SERVICE BULLETIN

HA15-006

January 19, 2016

2014 TAXI; A/C CONDENSER LEAK NEW RADIATOR CORE SUPPORT

Figure 2

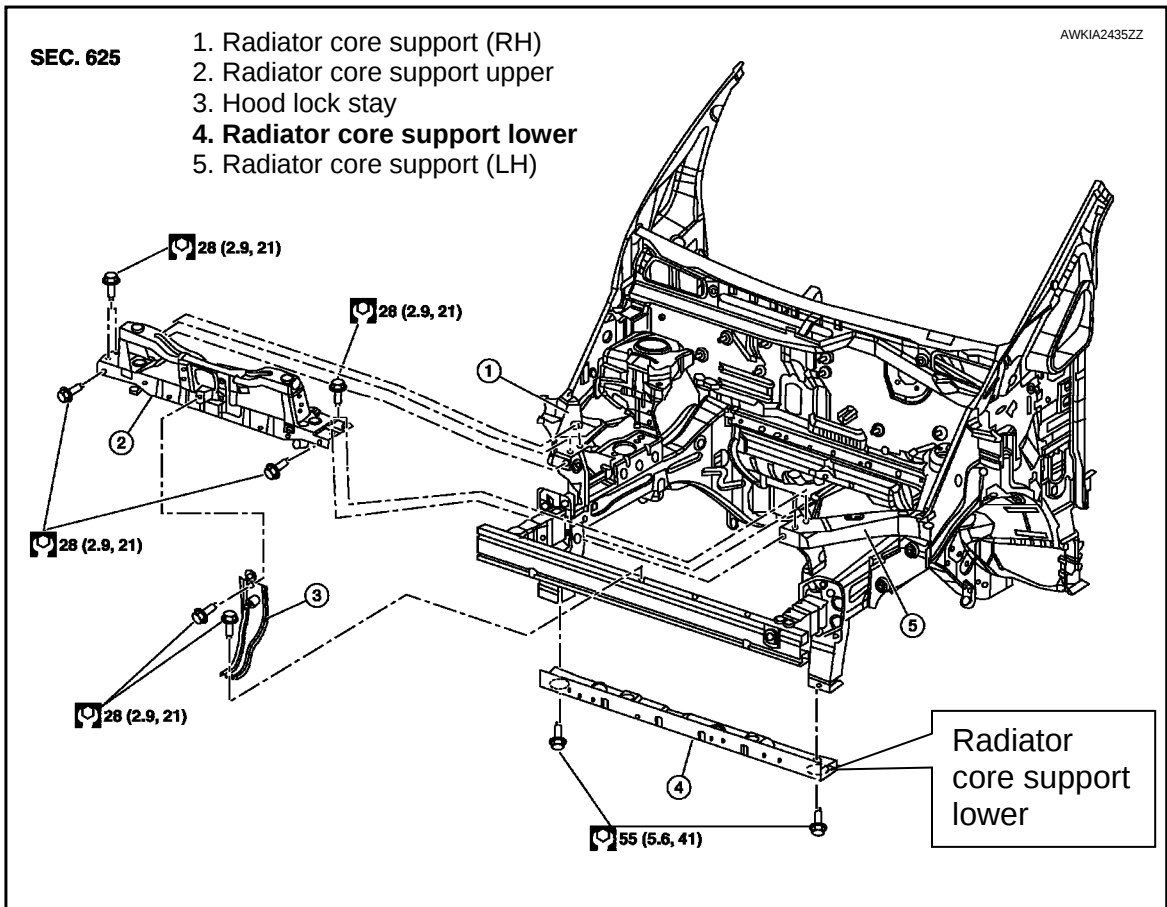
Replace the A/C condenser and the radiator core support lower.

- The radiator core support lower is shown in Figure 2 on the next page.
- Use the new radiator core support lower listed in the Parts Information.
- Refer to the Electronic Service Manual (ESM) for replacement information.
 - For the condenser; ESM section HA – Heater & Air Conditioning System
 - For the radiator core support lower; ESM section DLK – Door and Lock

DESCRIPTION	PART NUMBER	QUANTITY
A/C Condenser	92100-3LM0A	1
Radiator Core Support Lower	F2530-3LMAA	1
